Title: Lost Lake Development Review

To introduce and obtain preliminary feedback from the Minnehaha Creek Watershed District (MCWD) Board of Managers regarding development proposed by Monarch Development Partners at 2400 and 2420 Commerce Boulevard, Mound.

Attachment A – Development Concept Introduction

**2400-2420 Commerce Blvd, Downtown Mound
Development Concept Introduction**

**40' Wetland Buffer
at 2400-2420 Commerce Blvd.**

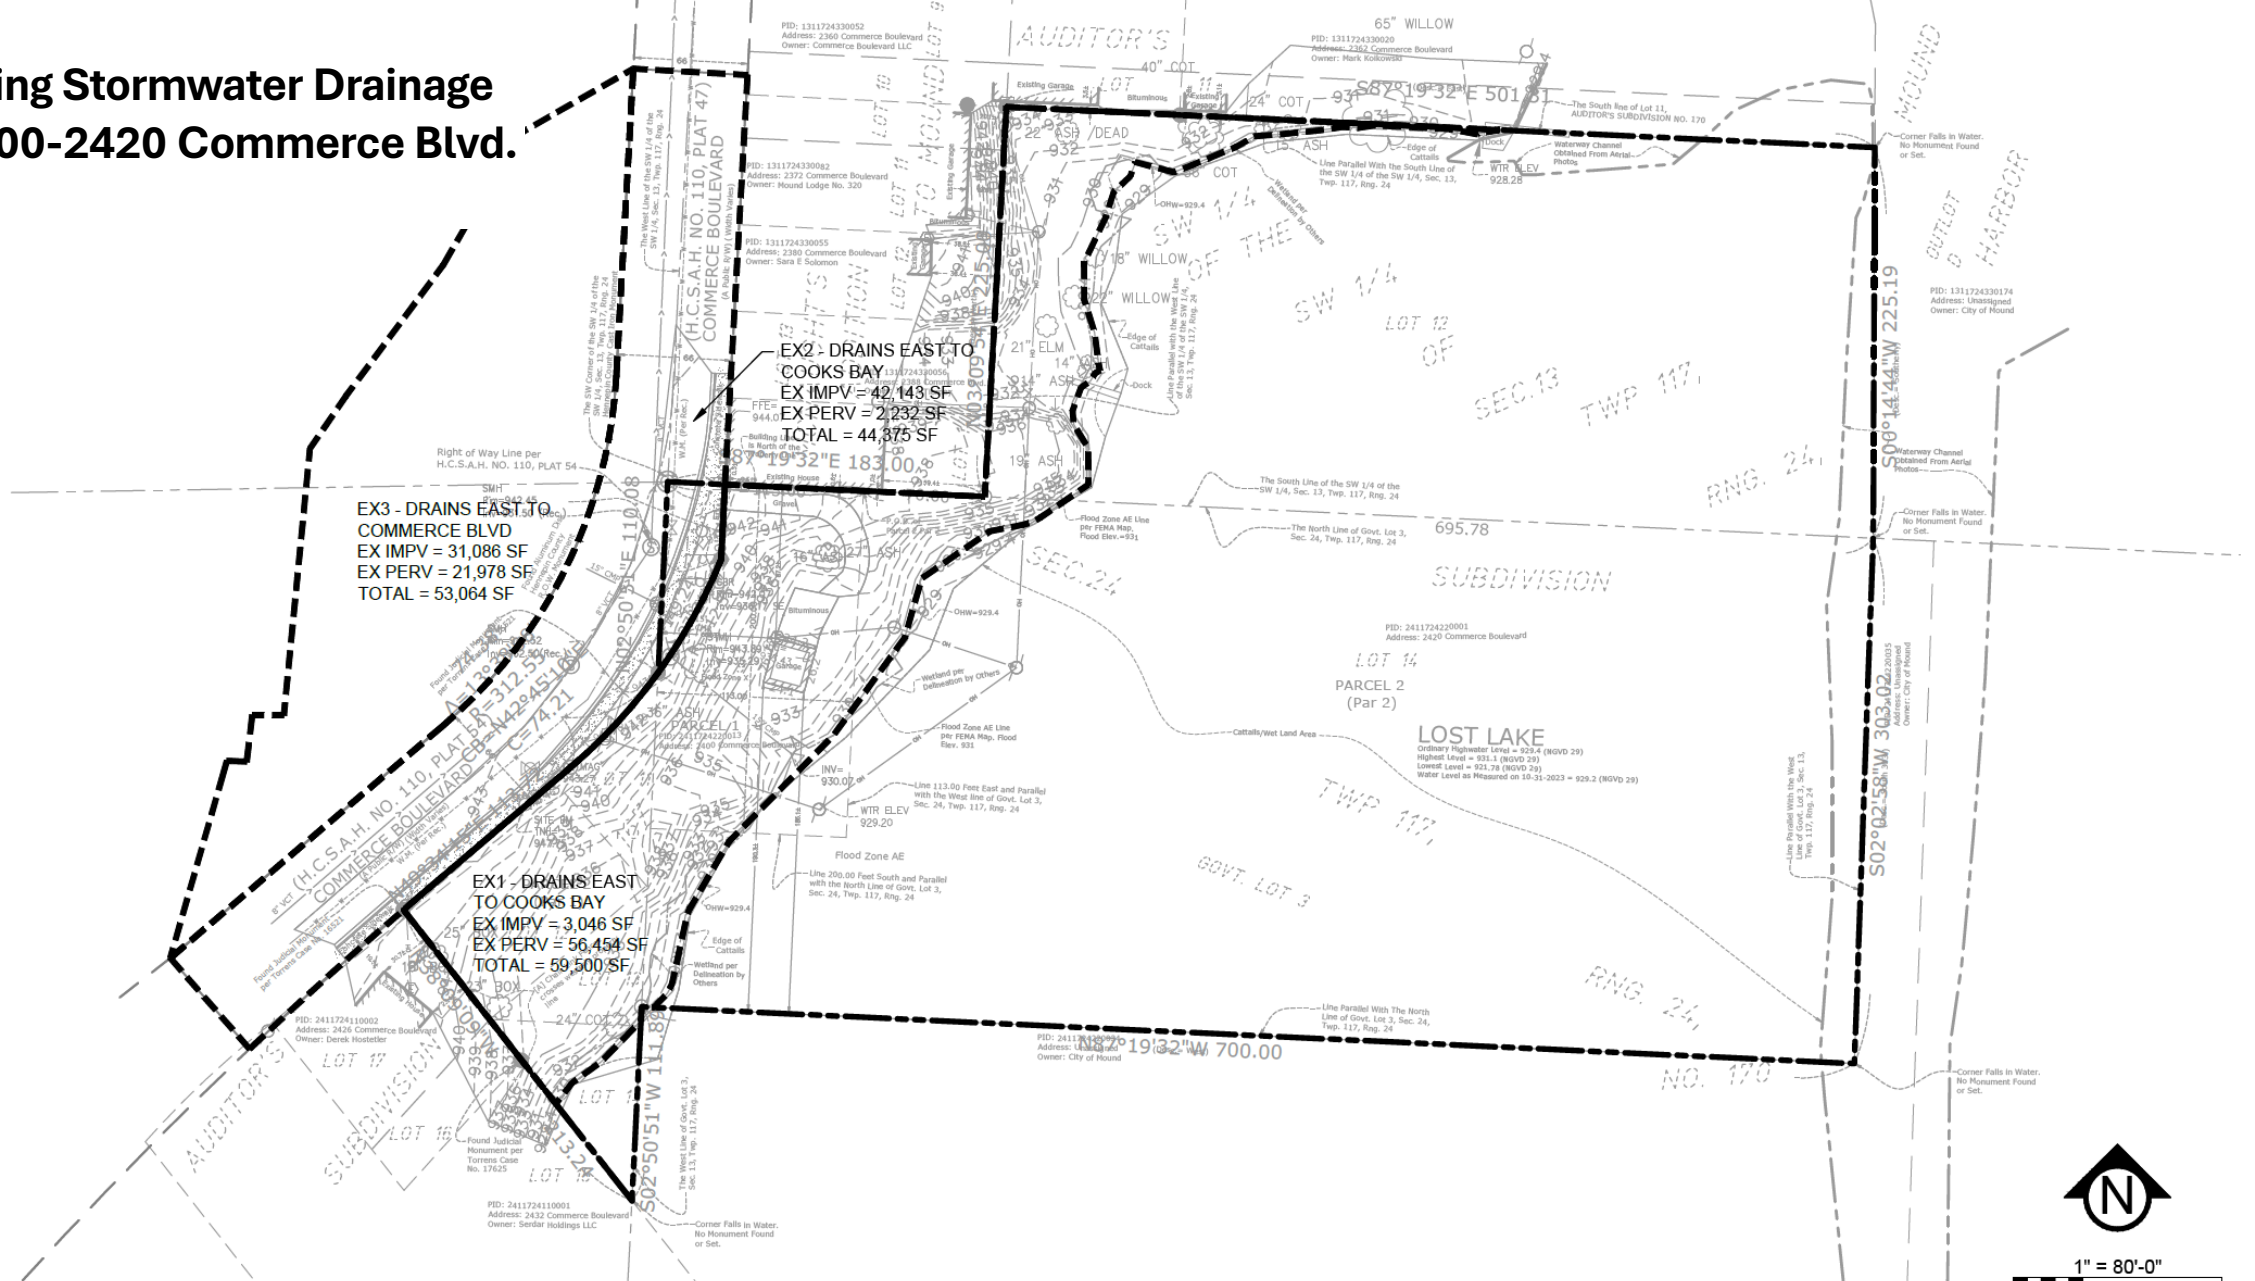
Lost Lake is identified by MCWD's Functional Assessment of Wetlands (FAW) as a Preserve Wetland, requiring a 75-foot buffer. Monarch Development Partners has been working with Kjolhaug Environmental Services, which has raised the potential to adjust the management classification from Preserve to Manage 1. This would reduce the required wetland buffer width to 40 feet, which would apply to all future wetland buffers that the District wetland rule would impose around Lost Lake. MCWD reviews any proposed wetland classification change under the Minnesota Routine Assessment Method (MnRAM), and with affiliated data, and would require detailed case-specific technical analysis that demonstrates that the proposed reclassification is due to unique characteristics of this site. Pages 11 and 12 of Attachment A contains site plans with the 75' and 40' buffers overlaid. In either case, the proposal would not meet the District's buffer requirement.

Under either a Preserve or a Manage 1 wetland classification, the currently proposed Project would require a Variance or Exception from the Wetland Protection Rule. This is due to the current site layout having multiple locations where the minimum buffer width is not met and the site being unable to achieve the required buffer area.

Proposed Stormwater Drainage at 2400-2420 Commerce Blvd.

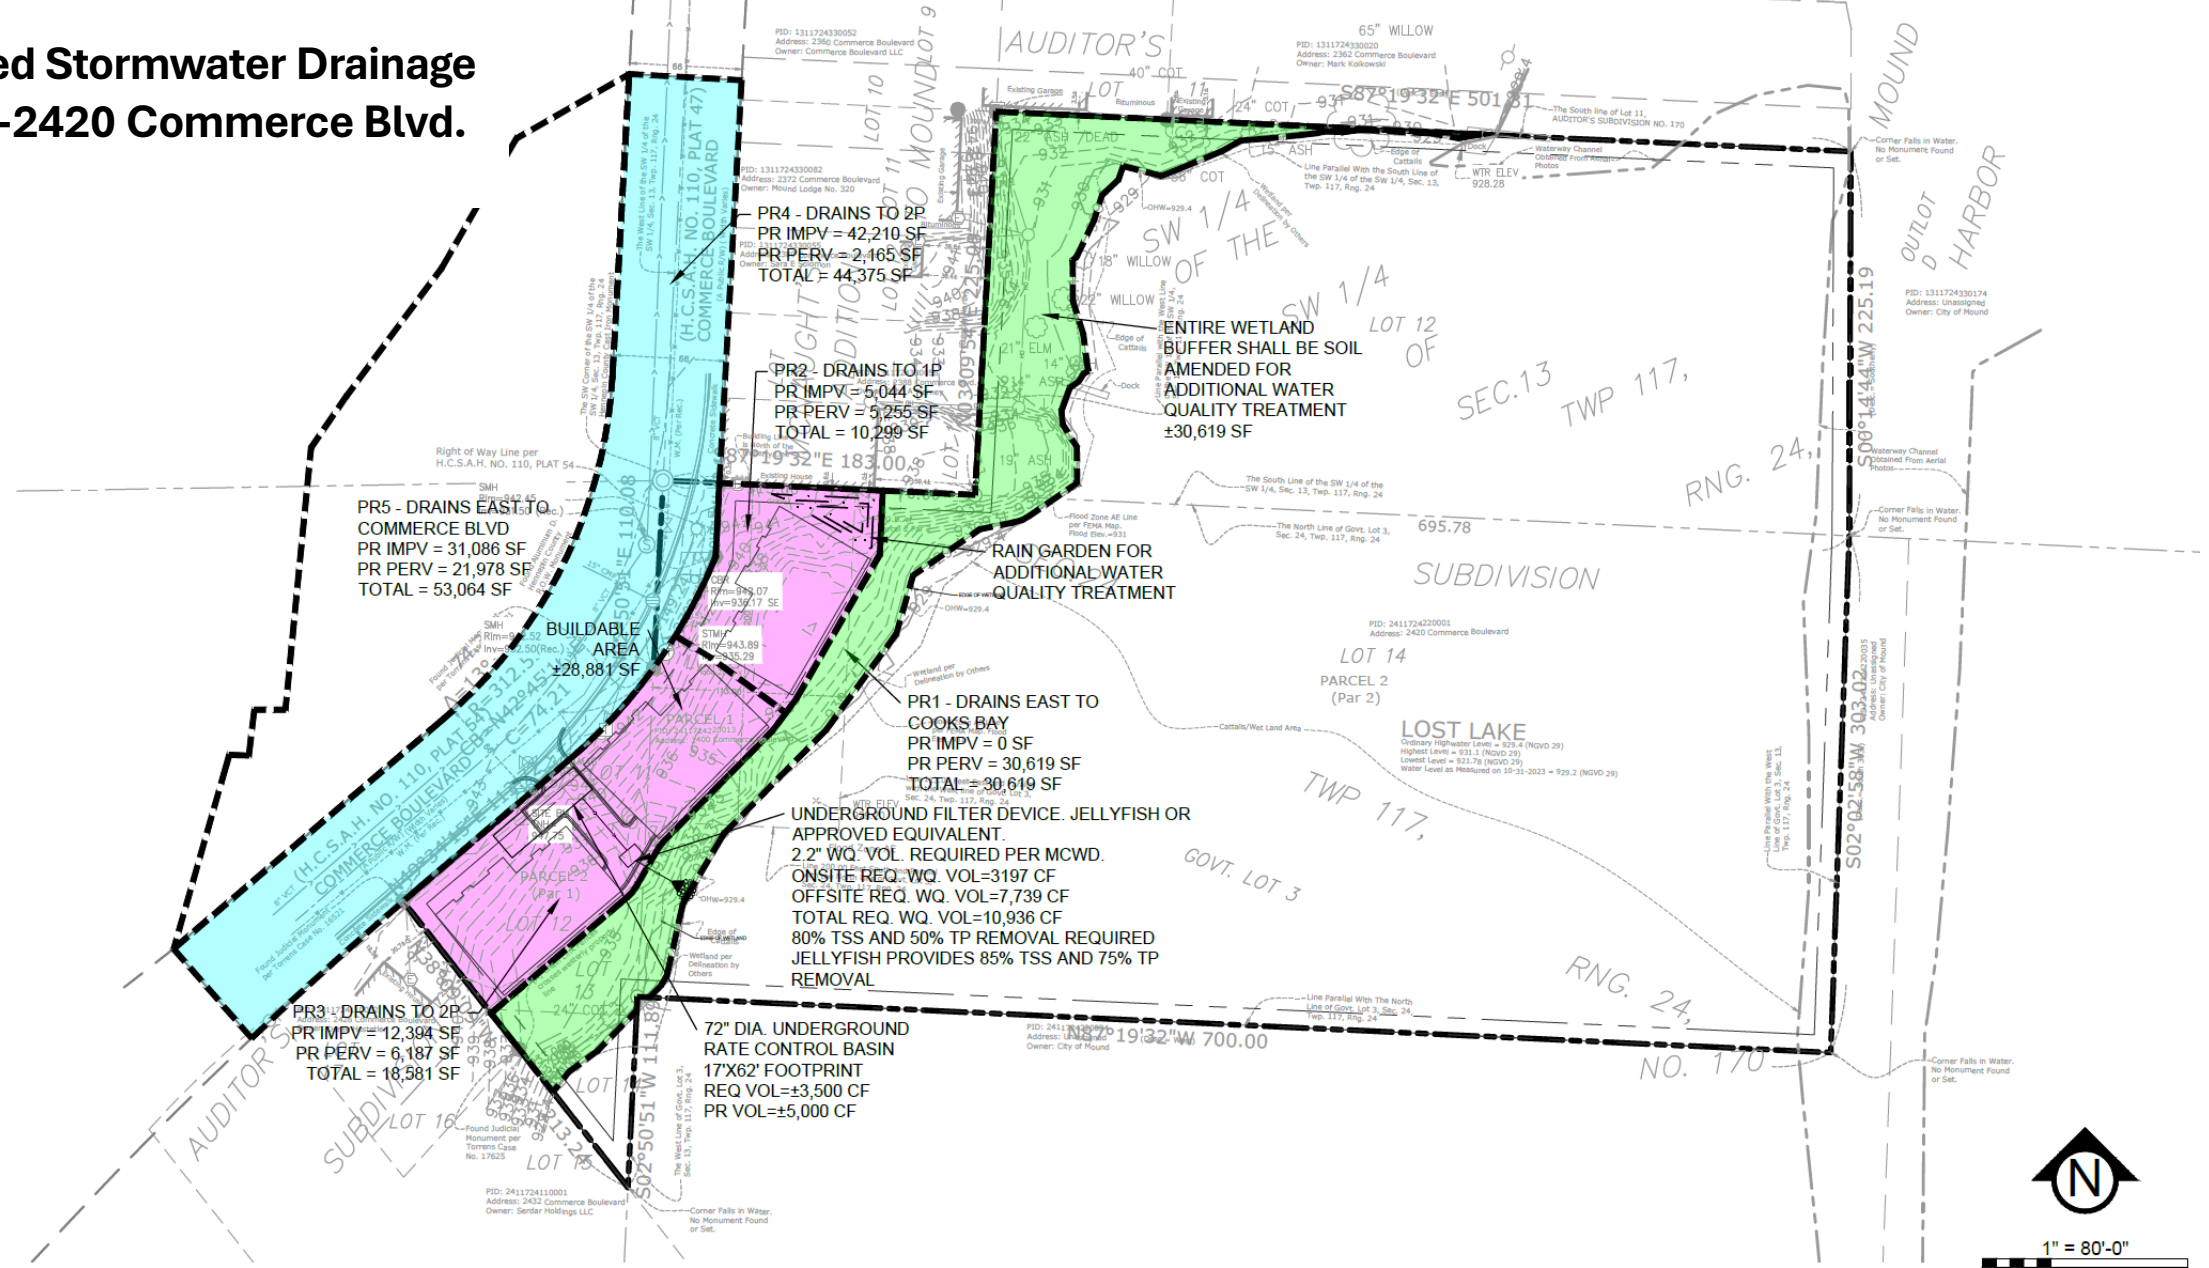
The Project is subject to Section 2(a) of the Stormwater Management rule and triggers the rule due to the site size, disturbance, and increase in impervious surface. Because the Project proposes to increase site impervious surface by over 50%, the entire site's post-development impervious surface must be treated for volume and rate control. The current proposal is to use underground filtration (consisting of underground detention pipes/chambers and a proprietary filter system) and a surface rain garden. As an additional benefit, the Applicant intends to expand treatment to include currently untreated runoff from public road right-of-way (Commerce Boulevard) to meet and exceed the Stormwater Management Rule requirements. Pages 13 and 14 of Attachment A show the existing and proposed stormwater drainage.

The Applicant proposes underground filtration and a rain garden to meet and exceed stormwater requirements. In addition to treating the site's impervious surface, the Project proposes to capture approximately 0.97 acres of Commerce Blvd's currently untreated stormwater. The MCWD will require more detailed stormwater submittals included in the permit application, but the conceptual plan appears to meet and exceed the Stormwater Management rule requirements.
